STATE OF HAWAII
DEPARTMENT OF TRANSPORTATION
HIGHWAYS DIVISION
UTILITY PLAN
MAUNA KEA MAINTENANCE
BASEYARD
DANIEL K. INOUE HIGHWAY
Project No. 200A-01-10
Scale: As Shown Date: April, 2018

1	06-07-18	ADDENDUM NO. 4	
REVISION	DATE	DESCRIPTION	AA15

STATE OF HAWAII
DEPARTMENT OF TRANSPORTATION
HIGHWAYS DIVISION
SHOP BUILDING
MAUNA KEA MAINTENANCE BASEYARD
DANIEL K. INOUE HIGHWAY
Project No. 200A-01-10

MA3.2

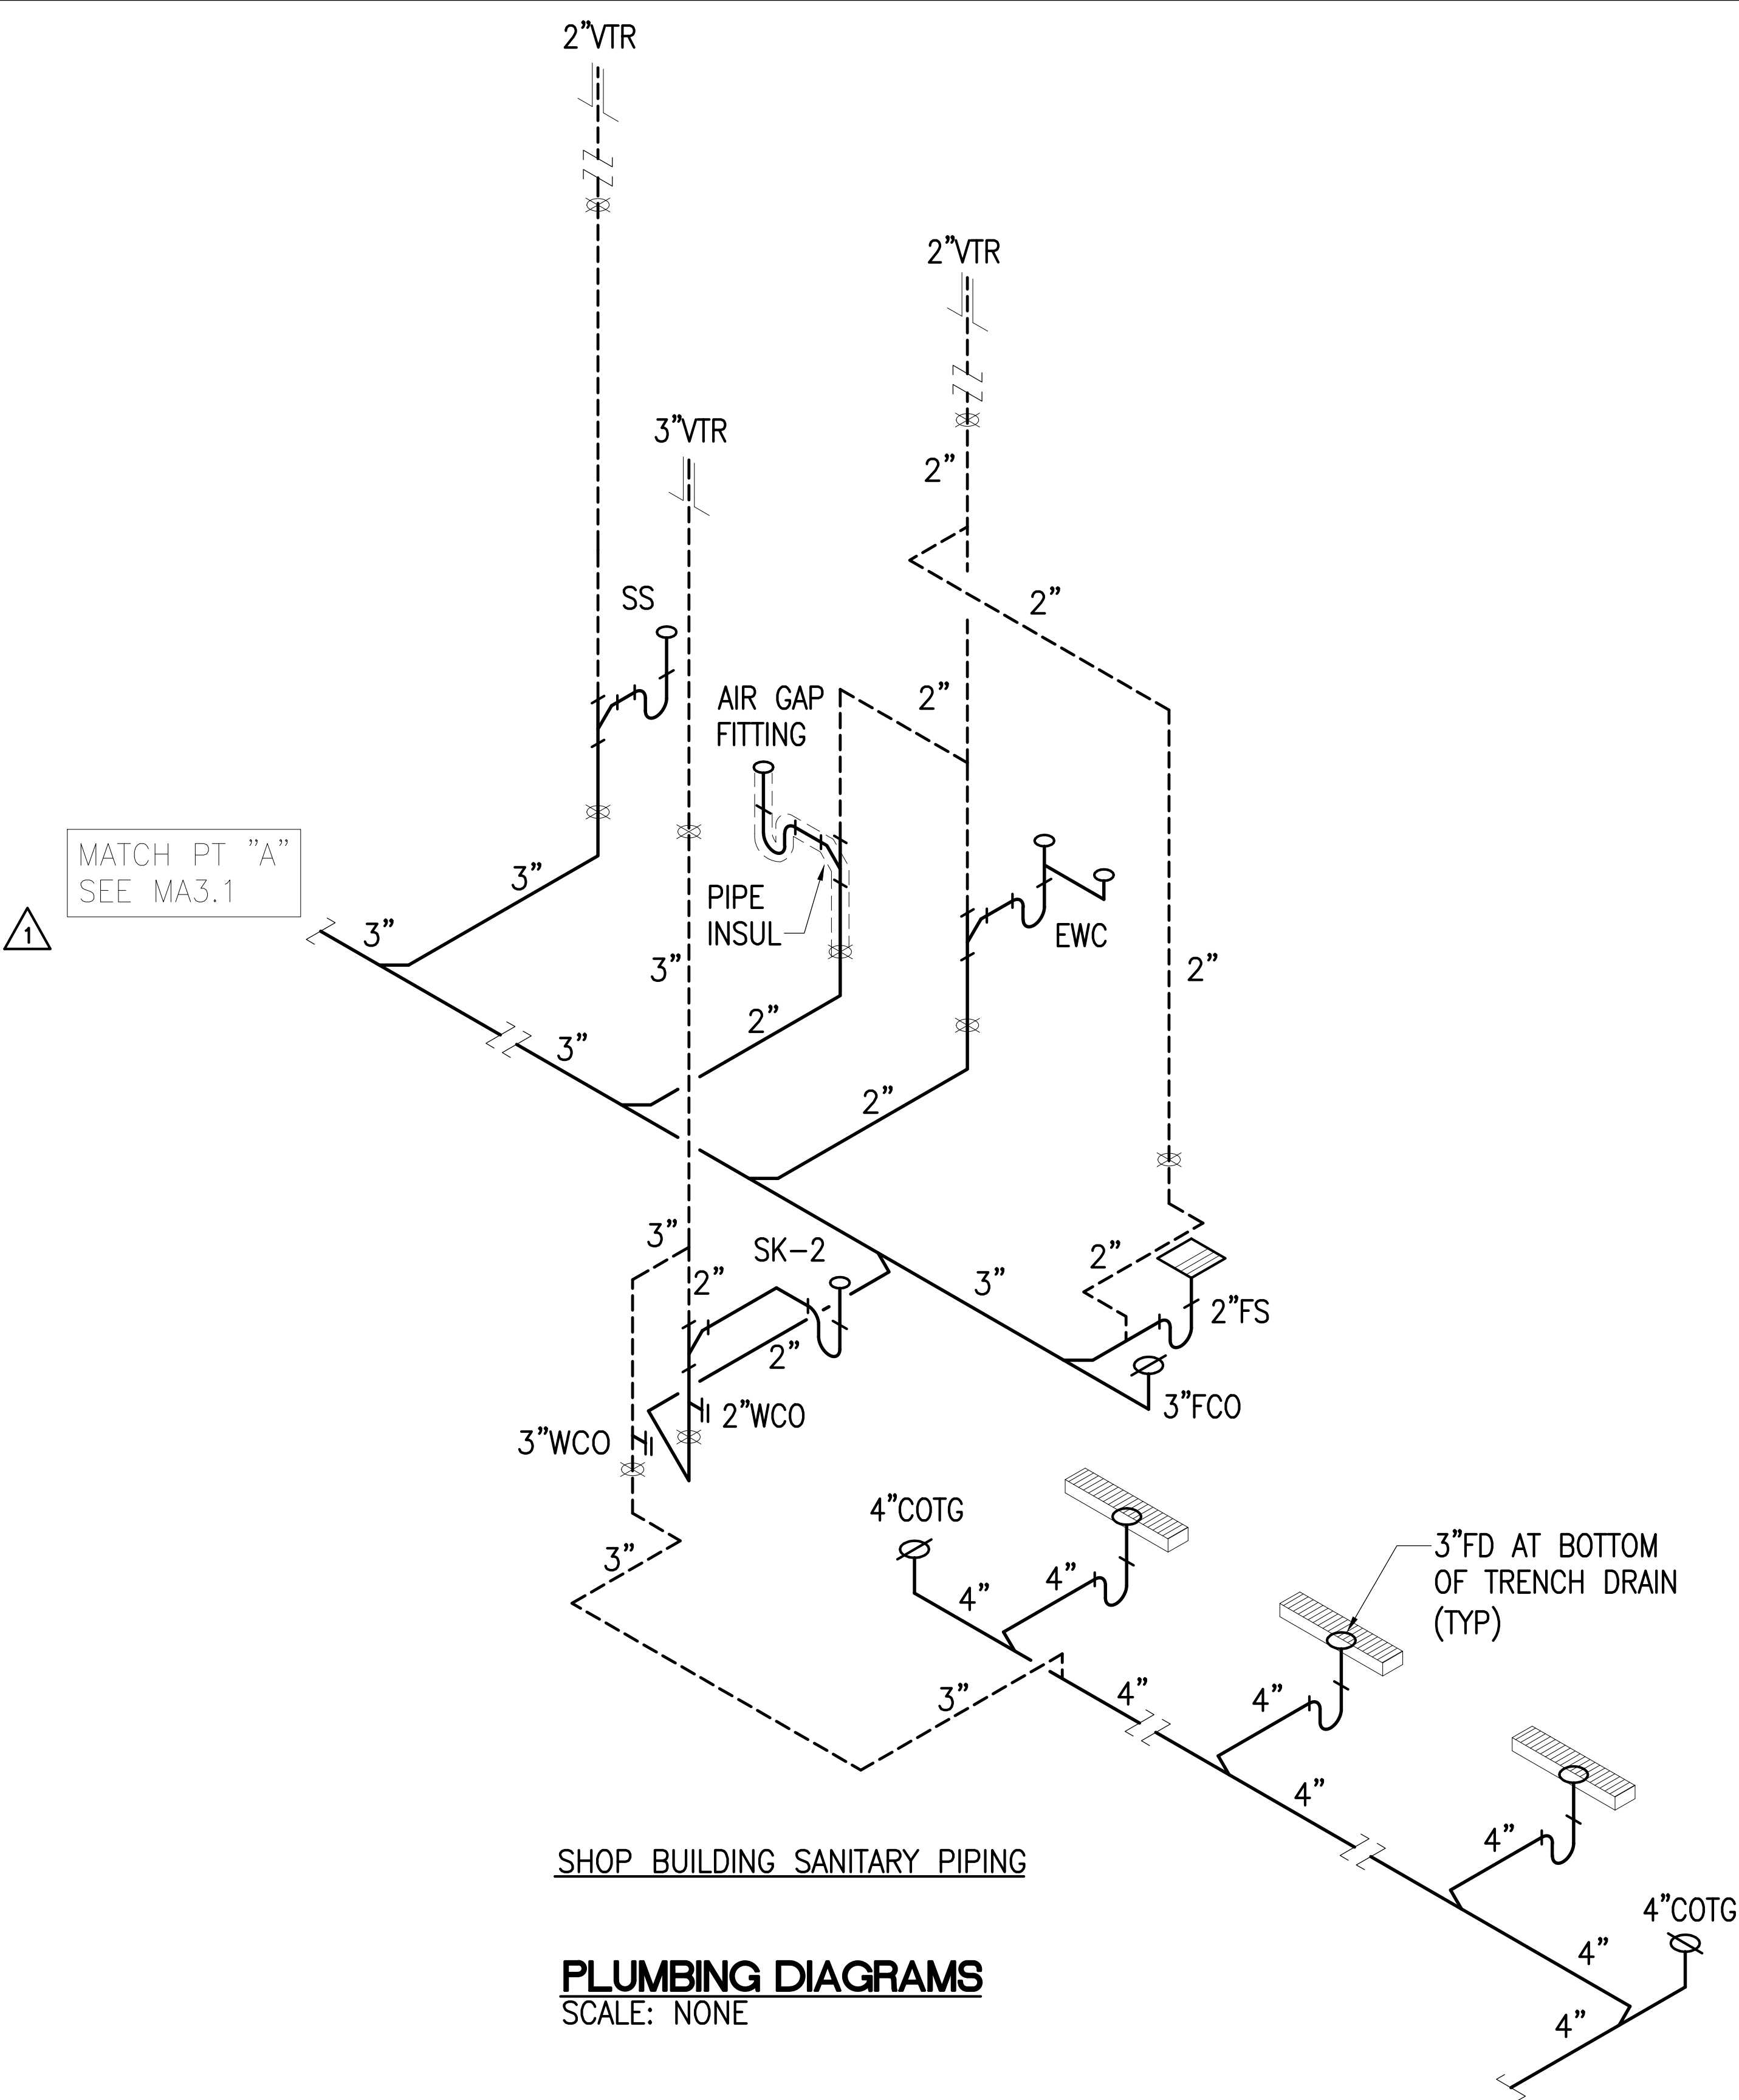
06-07-18	1 ADDED CLASSIFICATION NOTE
DATE	REVISION
STATE OF HAWAII DEPARTMENT OF TRANSPORTATION HIGHWAYS DIVISION <u>DIAGRAMS</u> <u>MAUNA KEA MAINTENANCE</u> <u>BASEYARD</u> <u>DANIEL K. INOUE HIGHWAY</u> <u>Project No. 200A-01-10</u> Scale: As Noted Date: April 2018	
SHEET No. MA3.2 OF 19 SHEETS

MA3.3

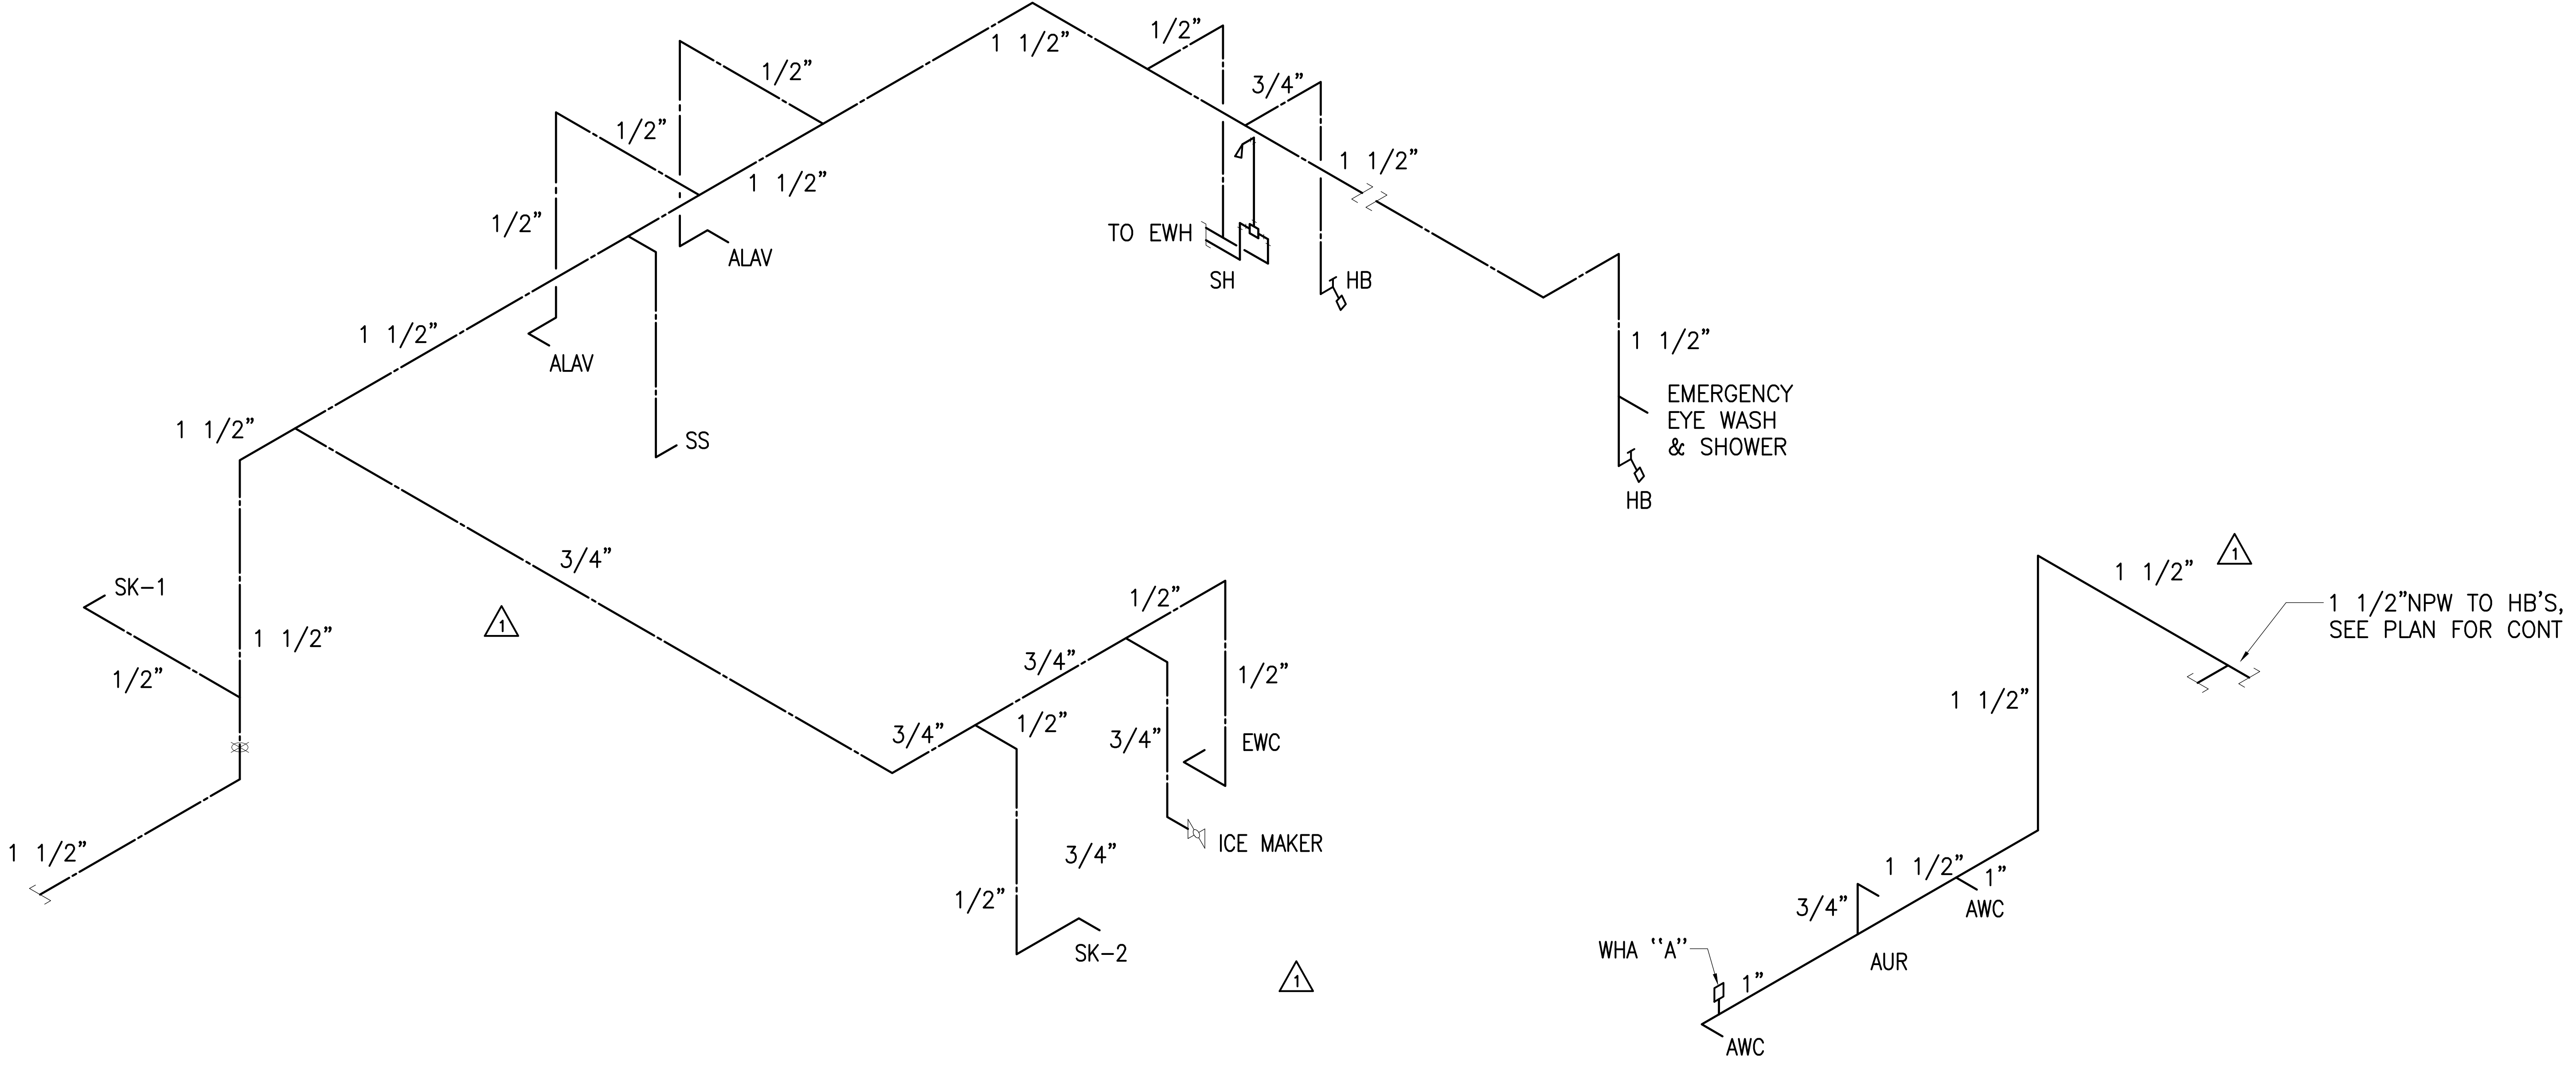
06-07-18	1	REVISED WATER & NPW DIAGRAM
DATE	REVISION	
Signature: <i>Keith M. Chan</i> EXP. DATE OF THE LICENSE: 04-30-20 THIS WORK WAS PREPARED BY ME OR UNDER MY SUPERVISION STATE OF HAWAII DEPARTMENT OF TRANSPORTATION HIGHWAYS DIVISION DIAGRAMS MAUNA KEA MAINTENANCE BASEYARD DANIEL K. INOUE HIGHWAY Project No. 200A-01-10 Scale: As Noted Date: April 2018 SHEET No. MA3.3 OF 19 SHEETS

E1.2

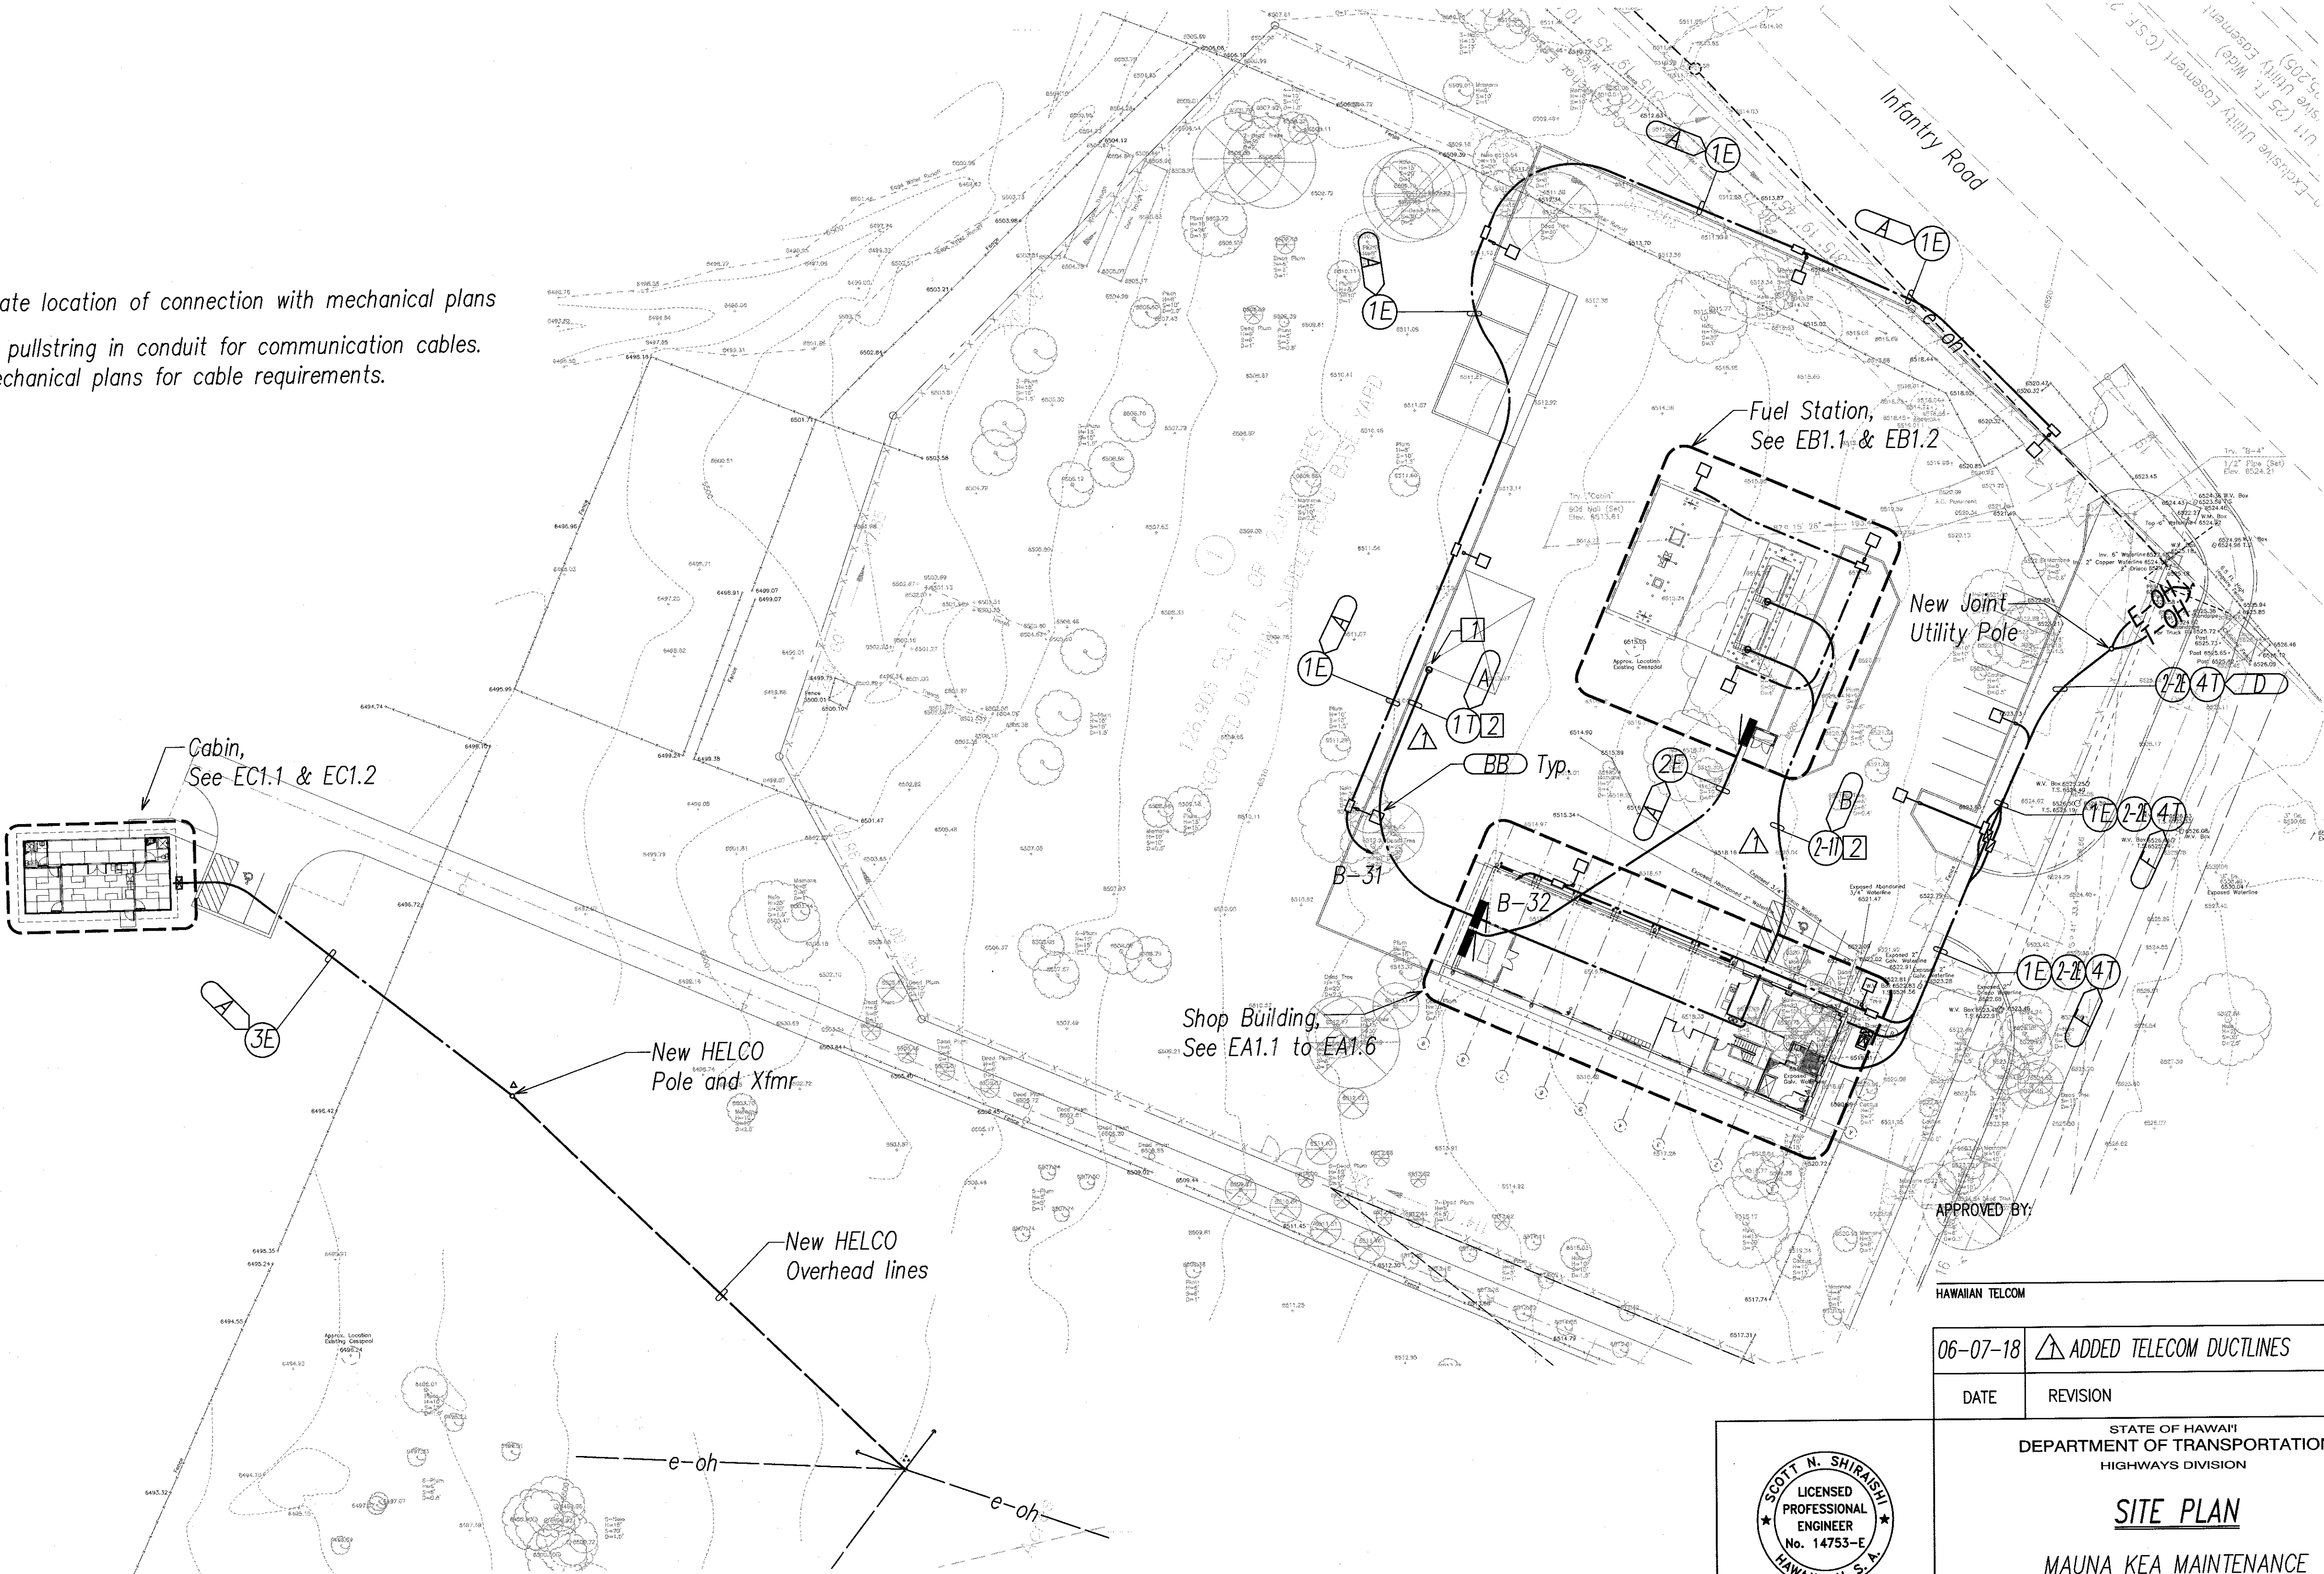
06-07-18	ADDED TELECOM DUCTLINES
DATE	REVISION
STATE OF HAWAII DEPARTMENT OF TRANSPORTATION HIGHWAYS DIVISION	
SITE PLAN	
MAUNA KEA MAINTENANCE BASEYARD	
DANIEL K. INOUE HIGHWAY Project No. 200A-01-10	
Scale: As Noted	Date: APRIL, 2018

- 1 Coordinate location of connection with mechanical plans
- 2 Provide pullstring in conduit for communication cables. See mechanical plans for cable requirements.
